Sterling Ranch East Filing NO. 4
SECTION 27, 28, 33 & 34 IN TOWNSHIP 12 SOUTH, RANGE 65 WEST OF THE SIXTH
PRINCIPLE MERIDIAN, EL PASO COUNTY, STATE OF COLORADO

DRAWING DESCRIPTION
**PRELIMINARY
LANDSCAPE -
OVERALL PLAN**

V1_Landscape Plan drawings.pdf Markup Summary

SHEET #
L-1

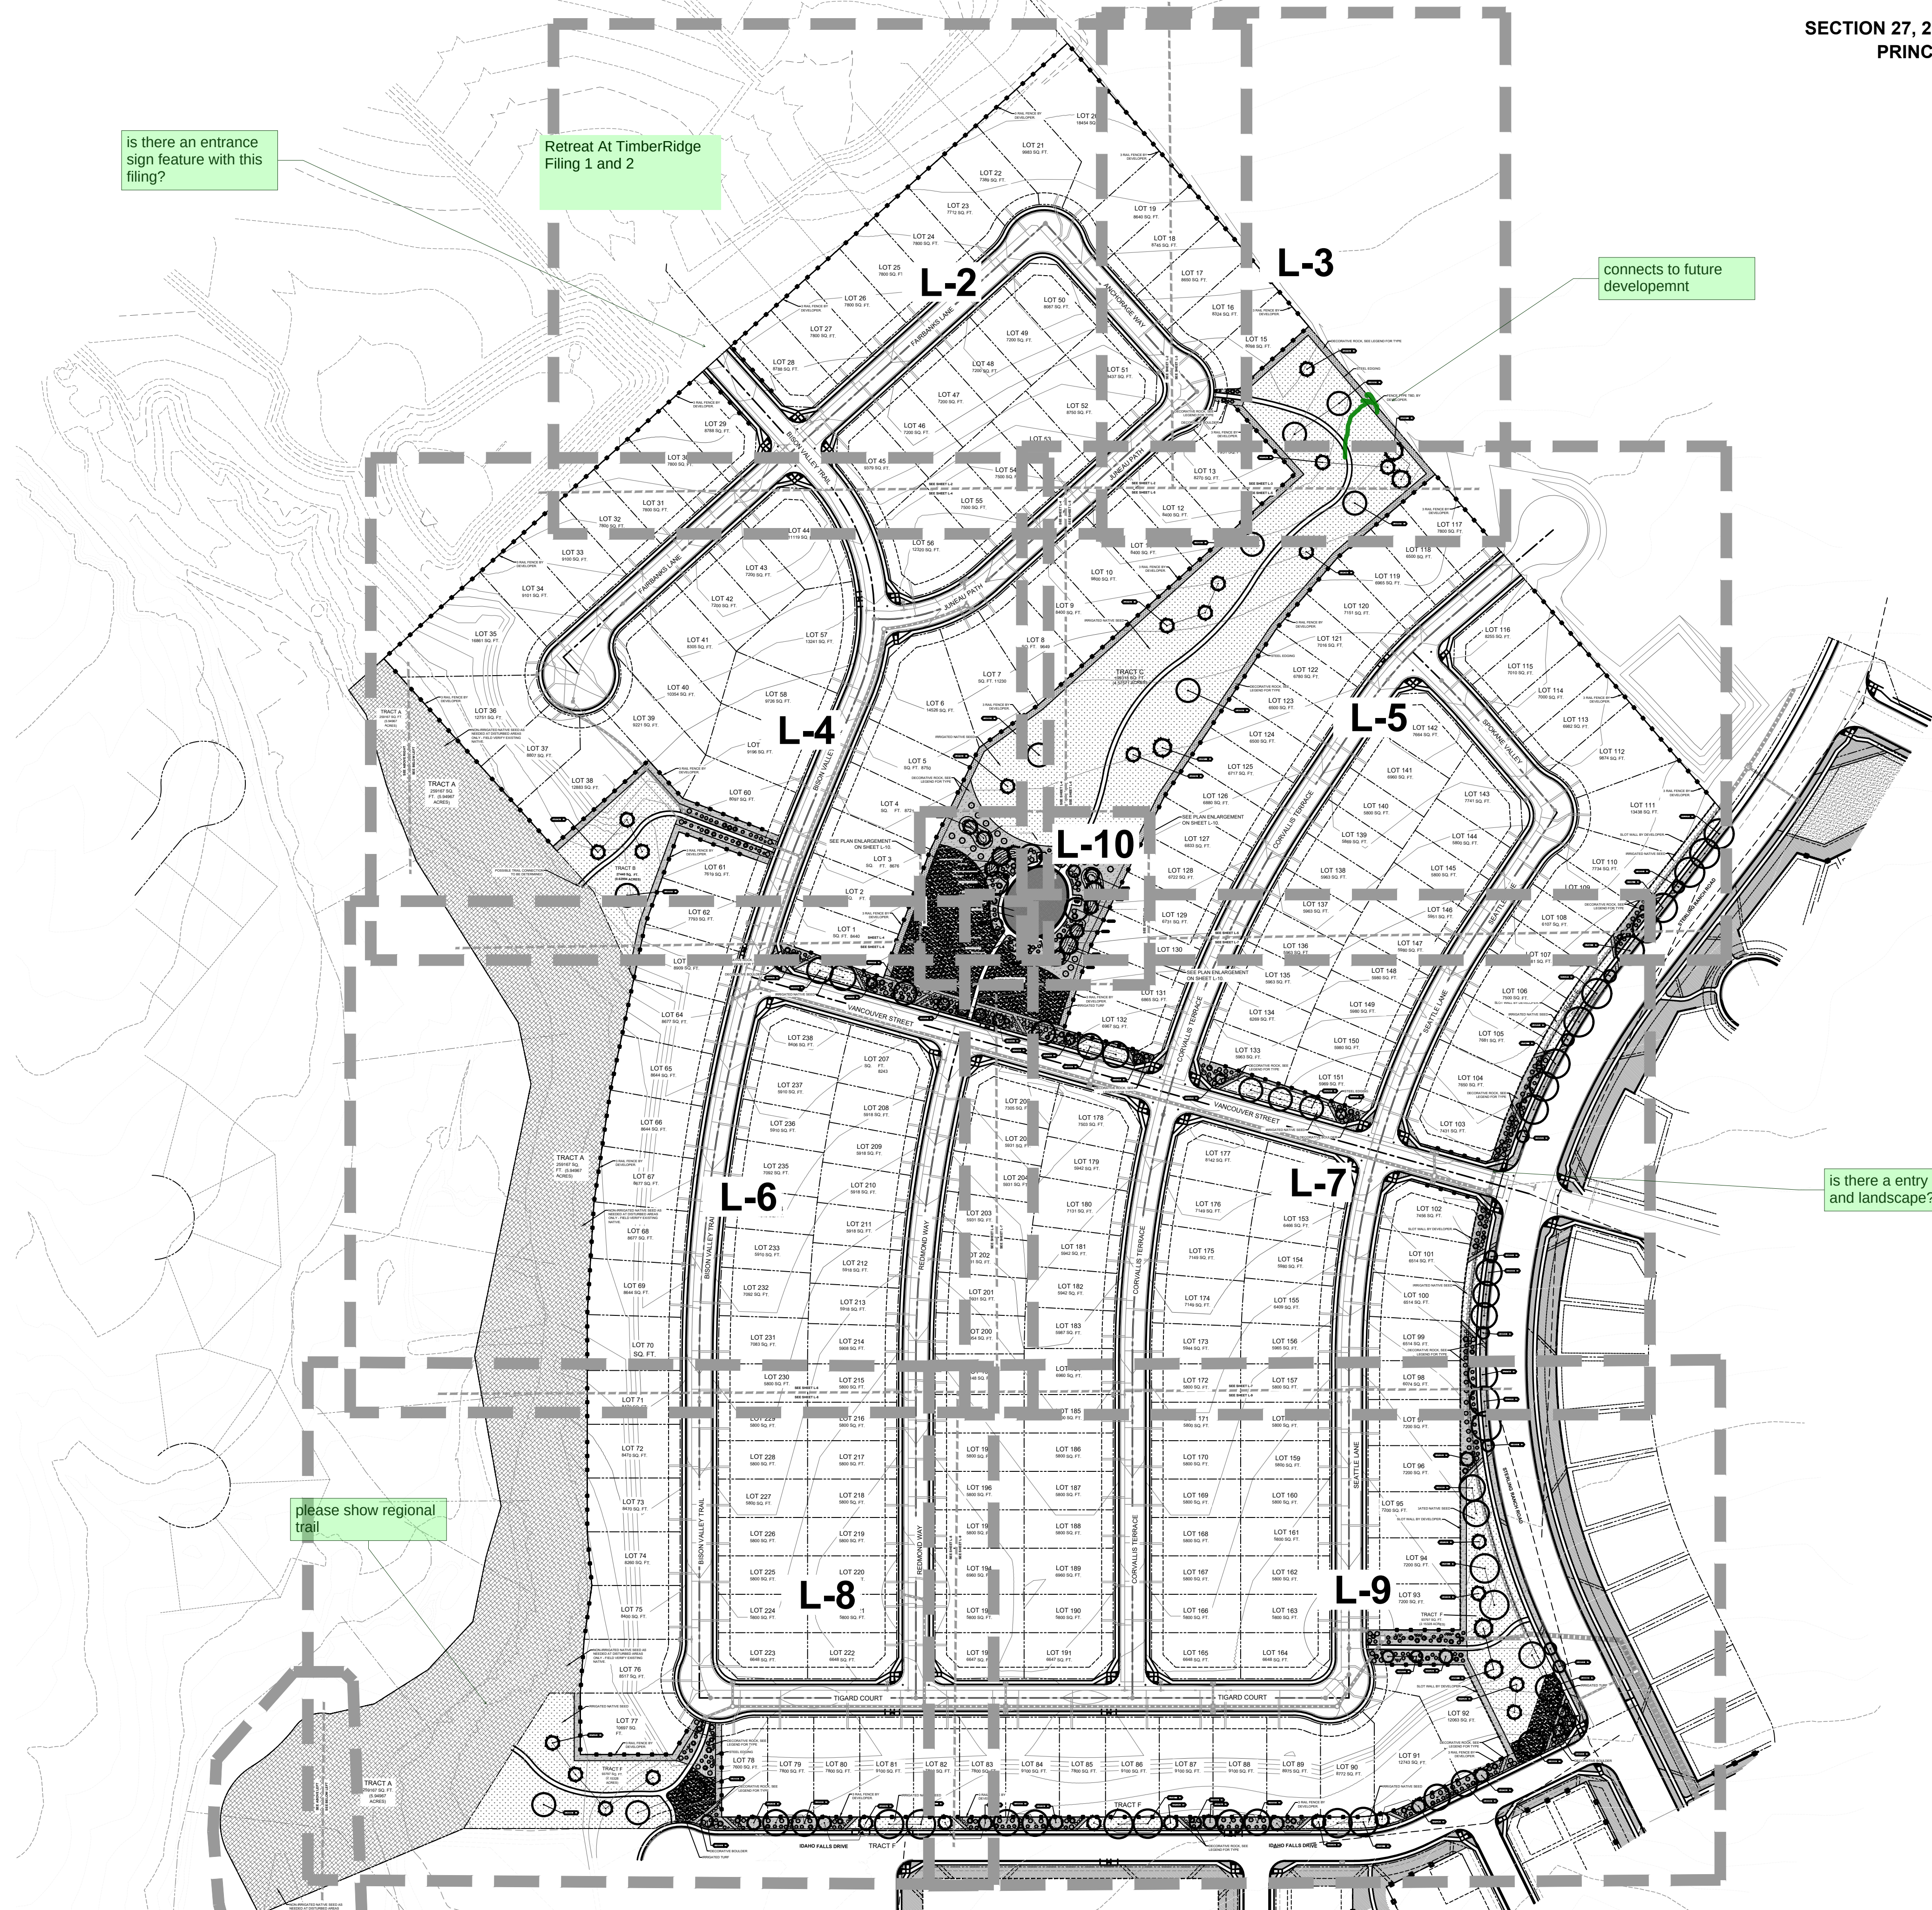
connects to future developemnt

please show regional trail

is there an entrance sign feature with this filing?

is there a entry sign and landscape?
